Addendum NO. 01

Date 5/20/2025
Project Name UCA Millcreek Head Start Renovation
Project Number 2025009
Project Phase Permit/Bid
Project Location 336 E 3900 S. Salt Lake City, UT 84107

PROJECT: UCA – Mechanical Addendum

1 LEVEL 1 FLOOR PLAN
A121 1/4" = 1'-0"

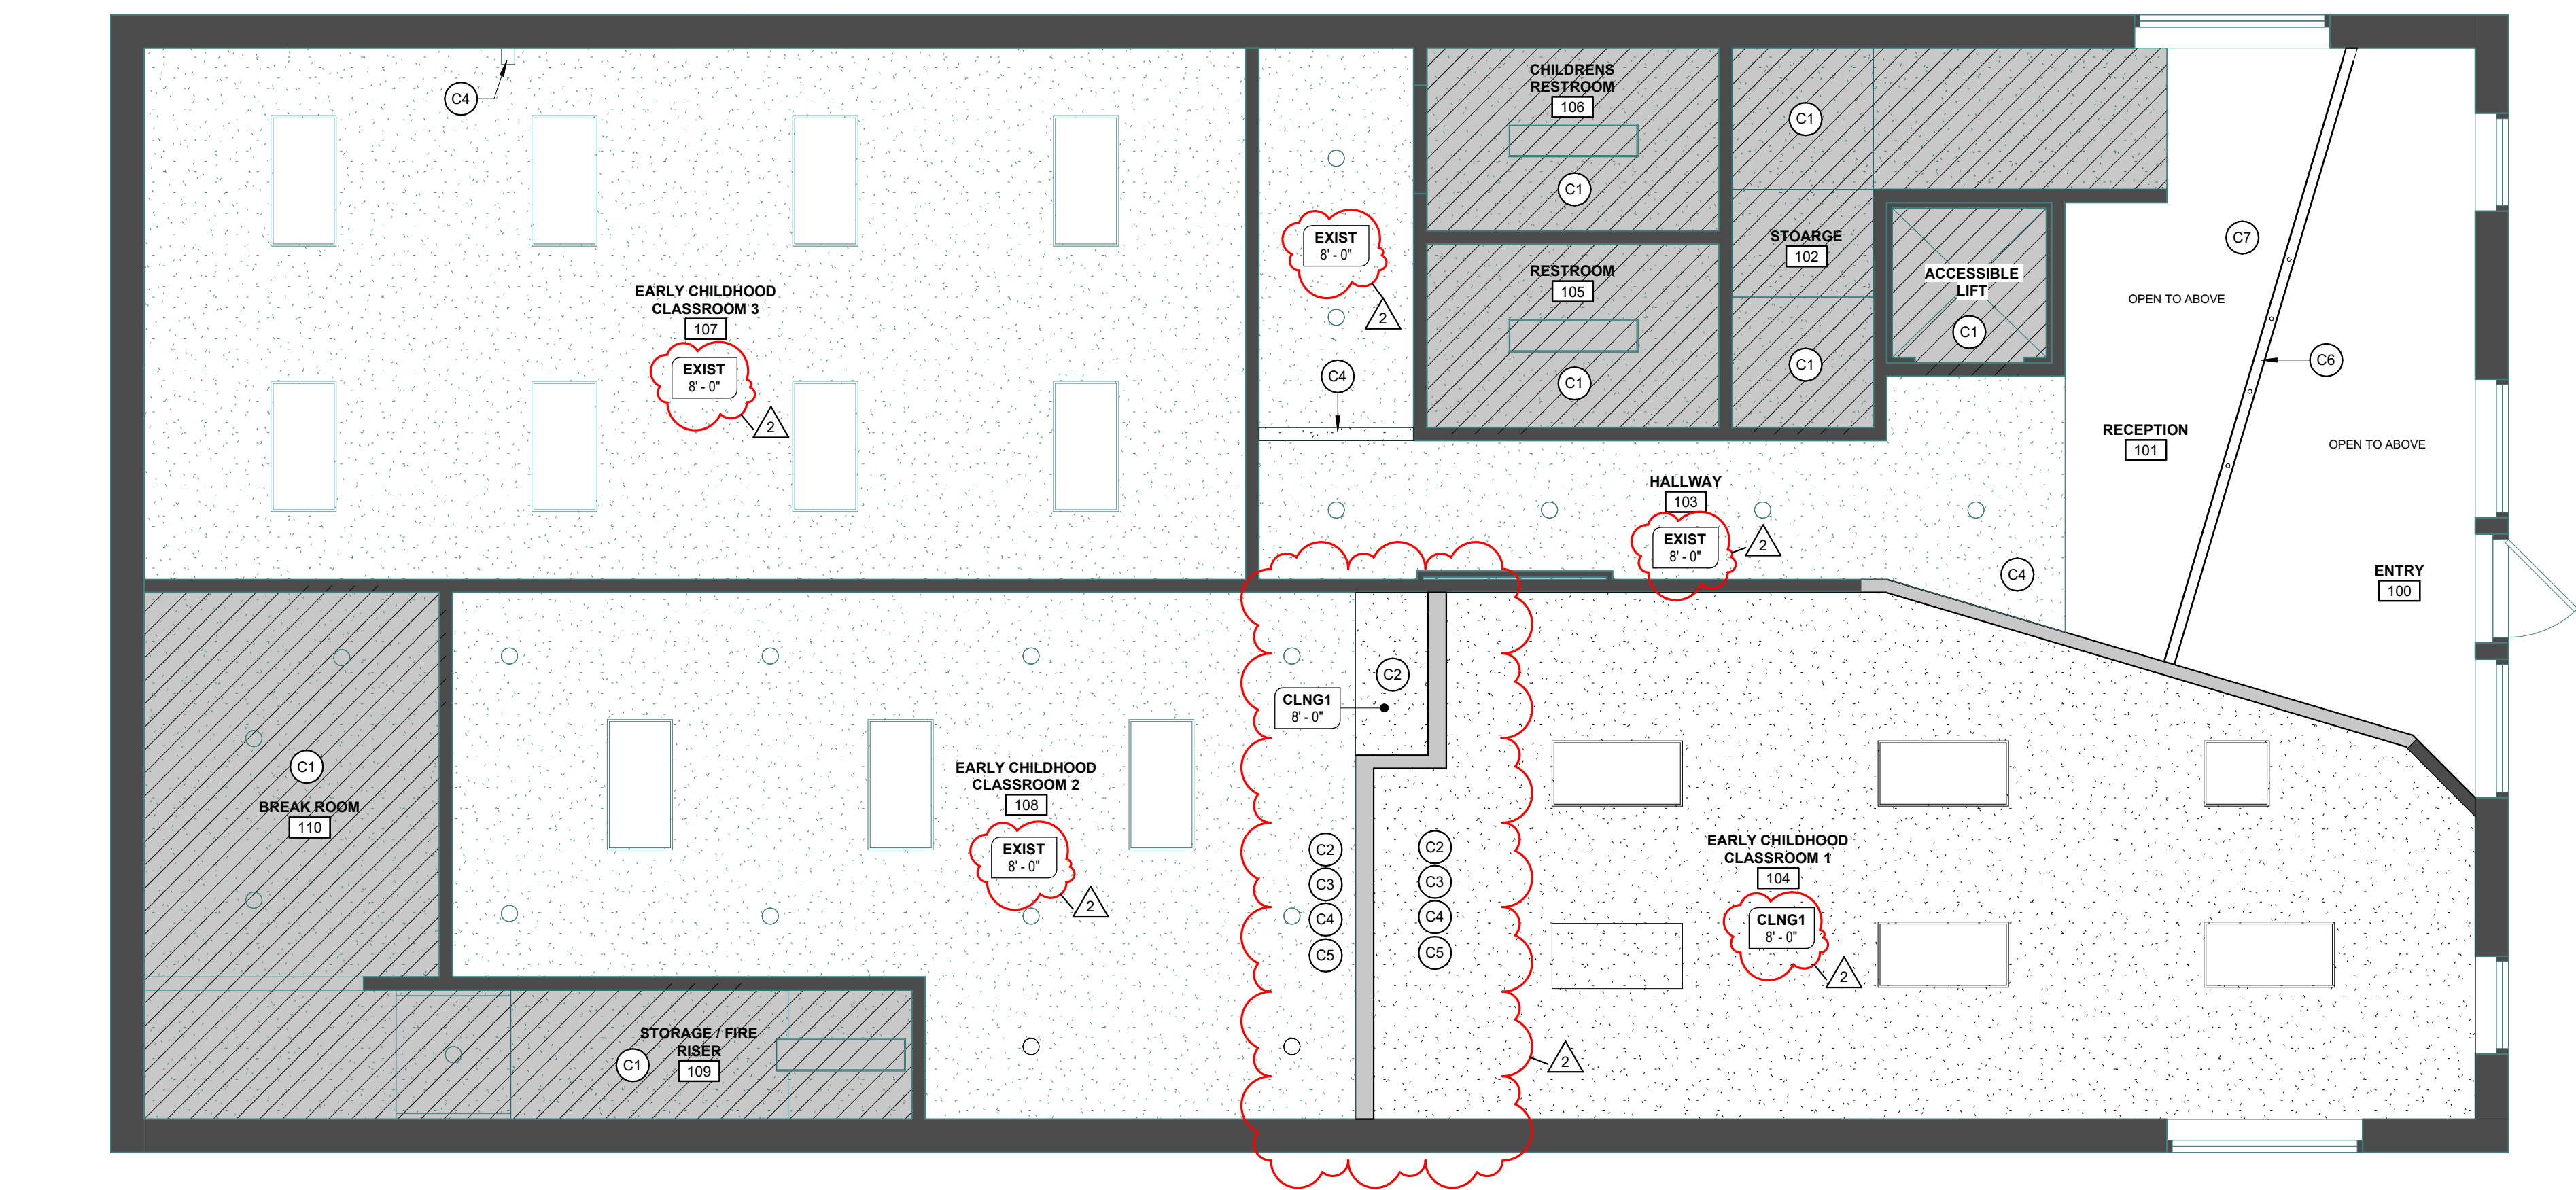
- 4. A121 – LEVEL 1 FLOOR AND REFLECTED CEILING PLAN**
- a. Detail 1/A121 – Revised detail and updated plan locations of single door, exterior windows, and interior walls & millwork based on existing field measurements.

- b. Detail 1/A121 – Removed children's toilet replacement. No demolition, fixtures are existing to remain.
 - c. Detail 1/A121 – Revised location of interior partition walls, millwork, and sinks between Early Childhood Classrooms 1 & 2.

2 LEVEL 1 REFLECTED CEILING PLAN
A121 1/4" = 1'-0"

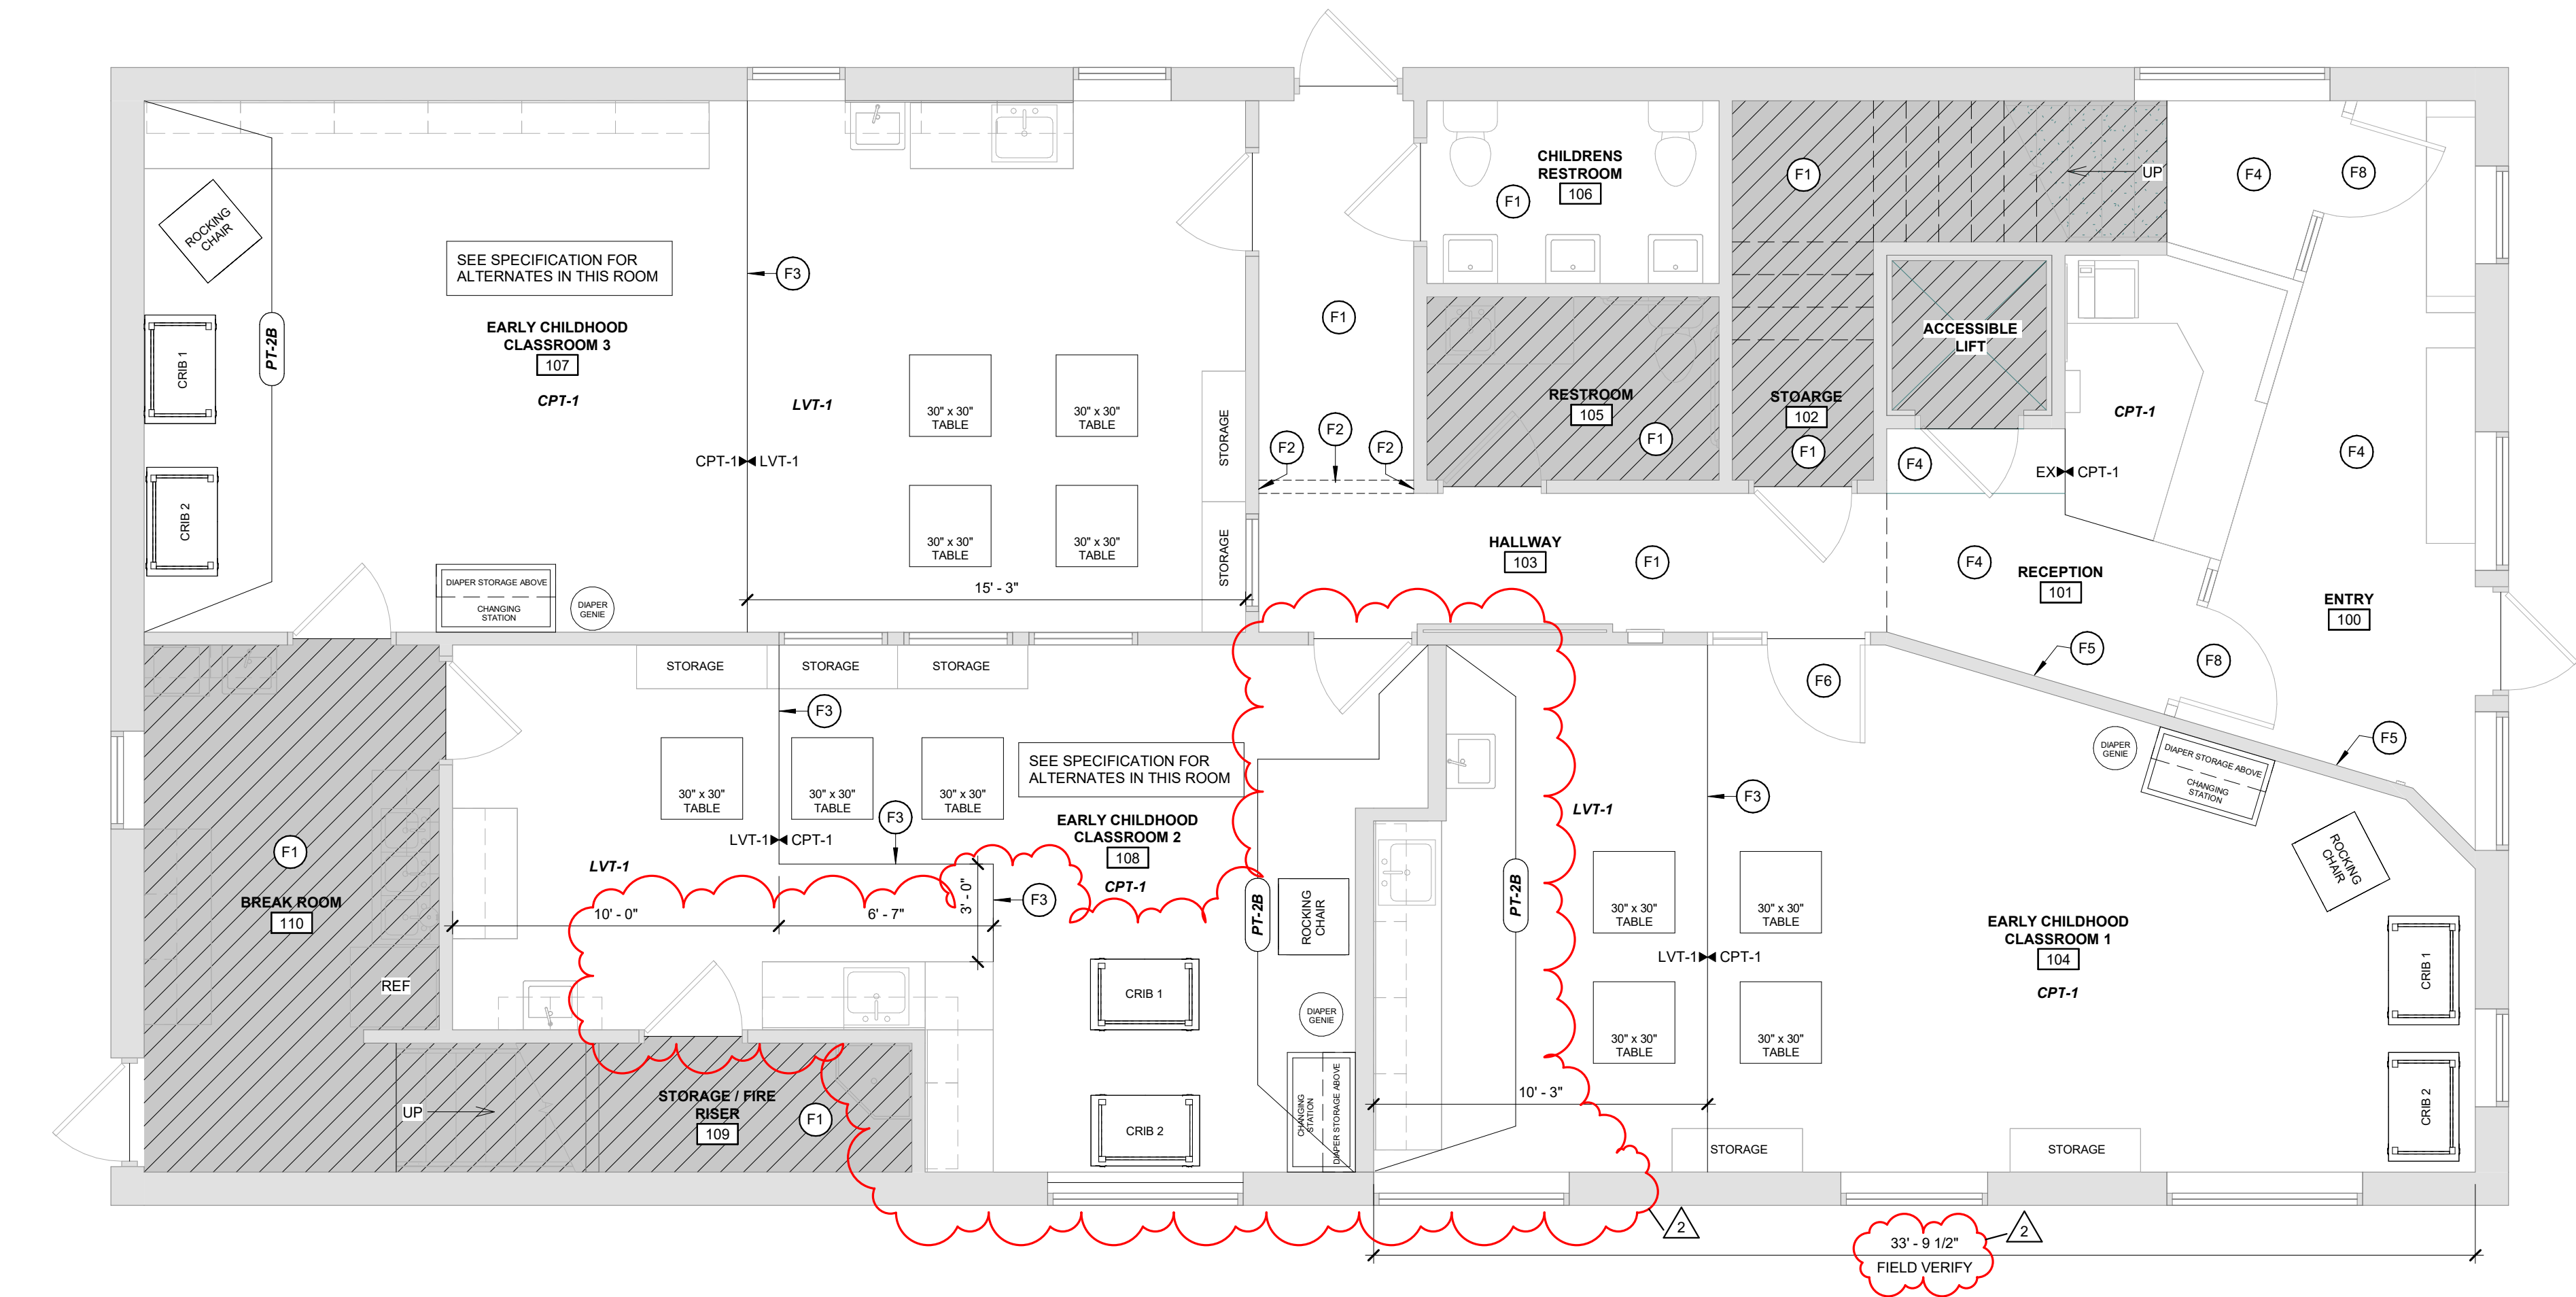
- d. General Keynote 13 – Revised keynote to read "NOT USED".
 - e. Detail 2/A121 – Revised extent of ceiling to be added and modified between Early Childhood Classrooms 1 & 2.

- f. Detail 2/A121 – Added ceiling elevation tags.
- 5. A131 – LEVEL 1 FINISH & FURNITURE, AND MILLWORK PLAN**
- a. Detail 1/A131 – Revised extents of wall and floor finishes.

1 LEVEL 1 FINISH & FURNITURE PLAN
A131 1/4" = 1'-0"

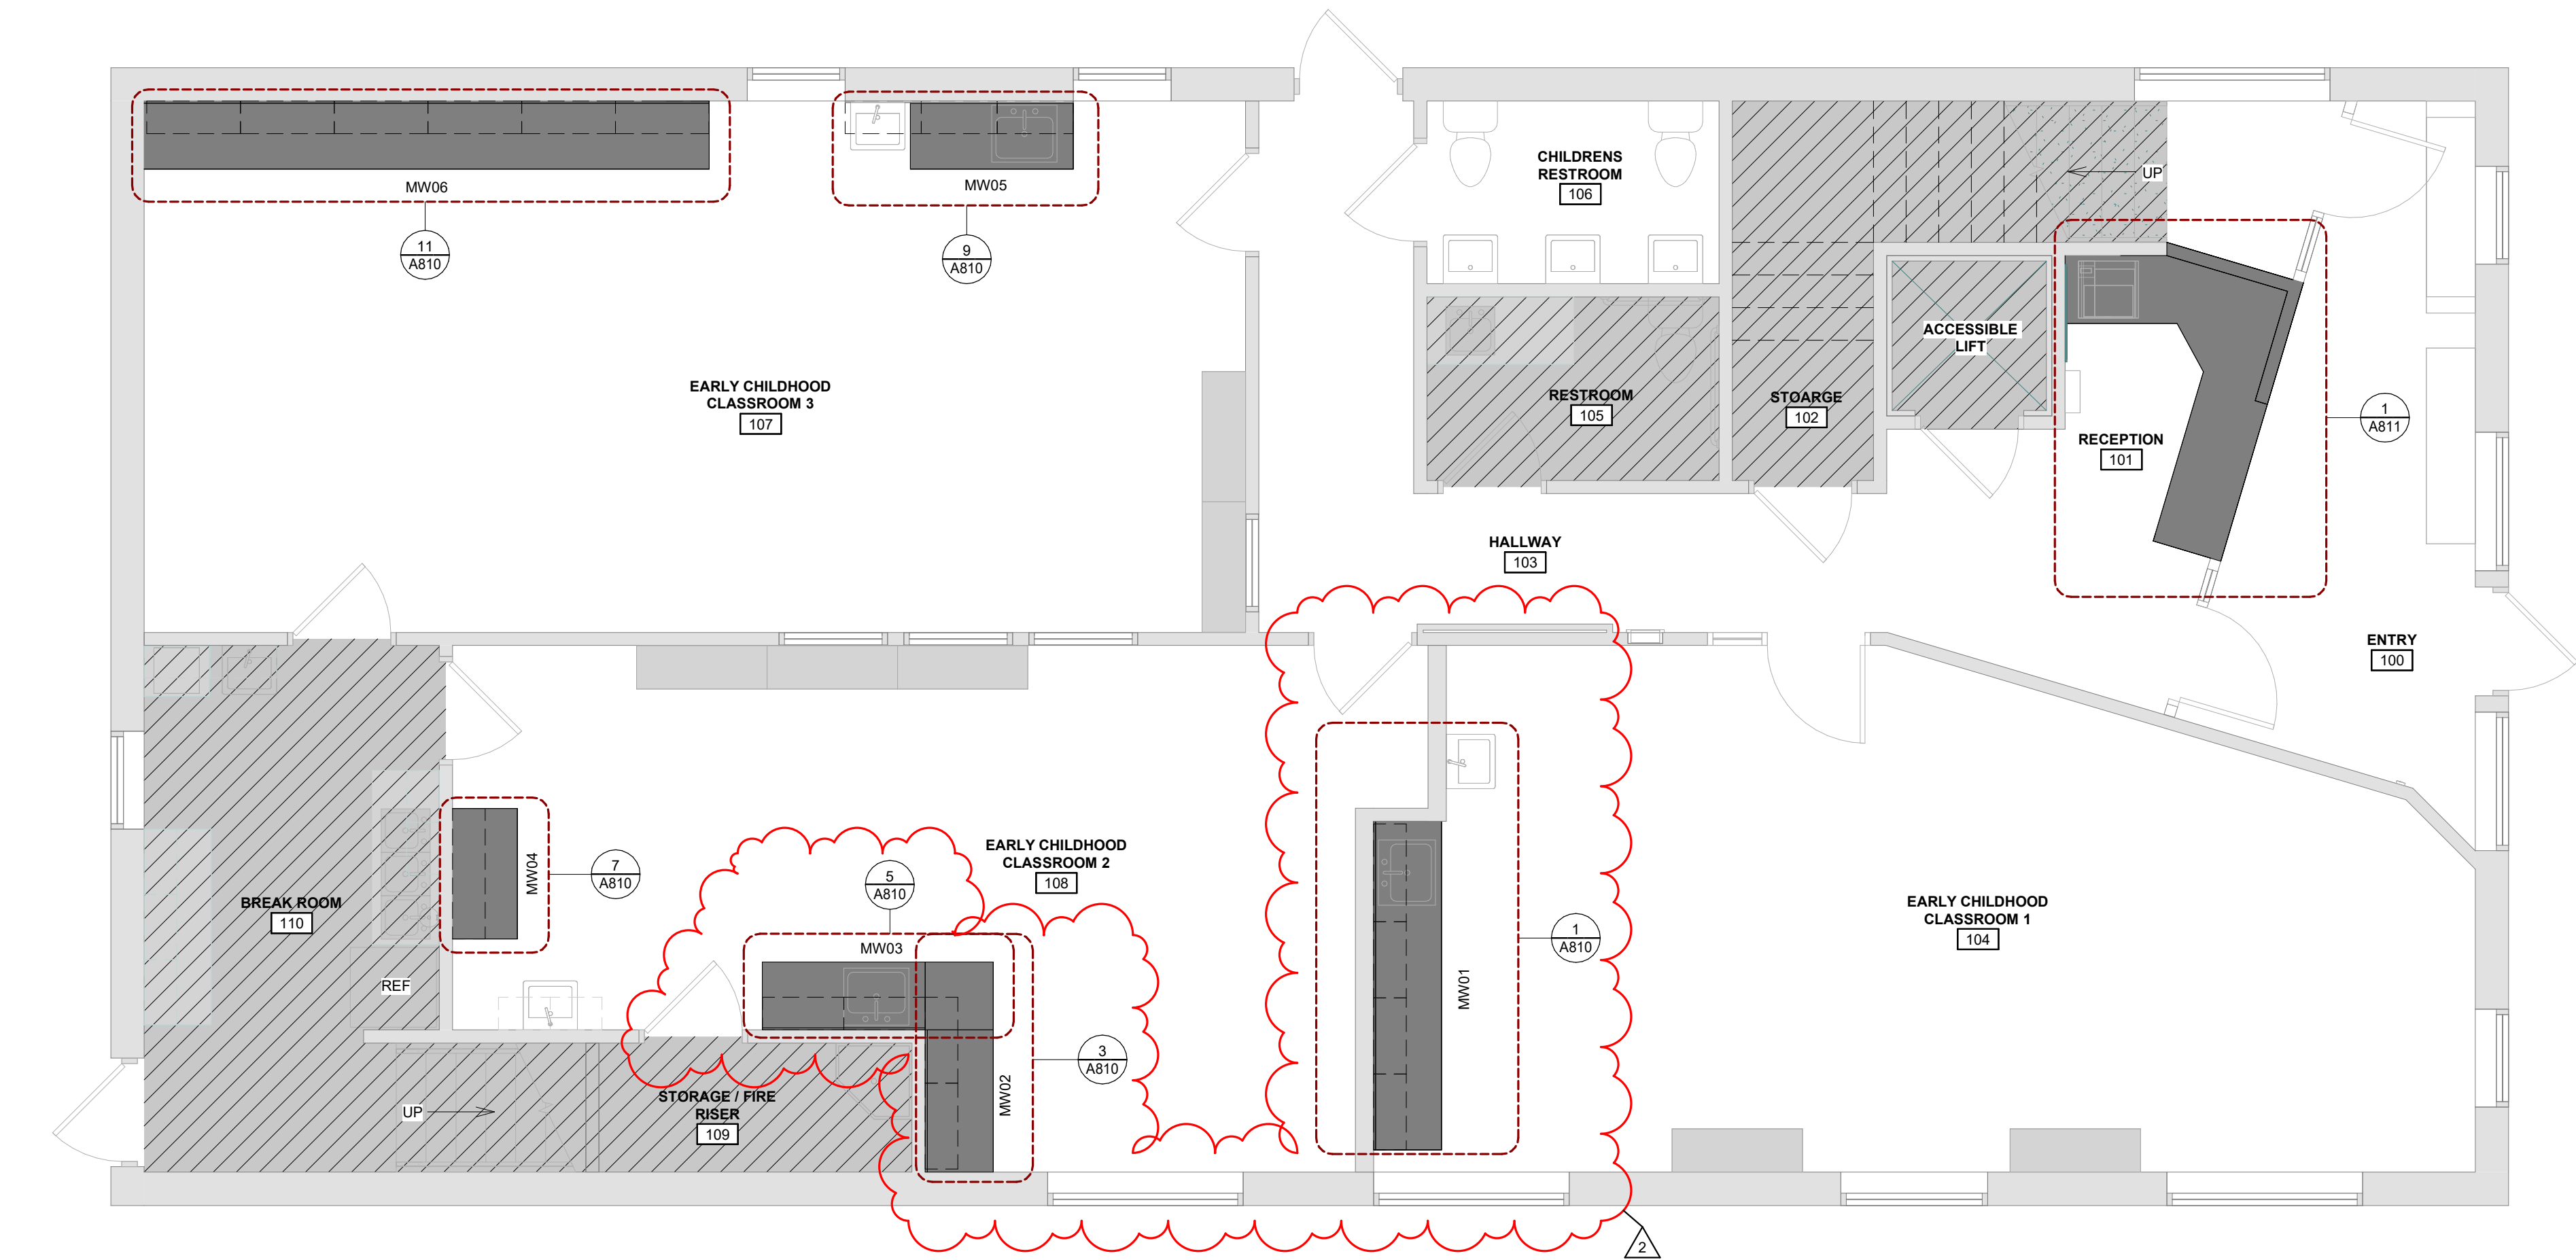
- b. Detail 1/A131 – Revised furniture location.
 - c. Detail 2/A131 – Revised millwork plan.
- 6. A501 – INTERIOR ELEVATIONS AND DETAILS**
- a. Detail 1/A501 – Revised elevation.
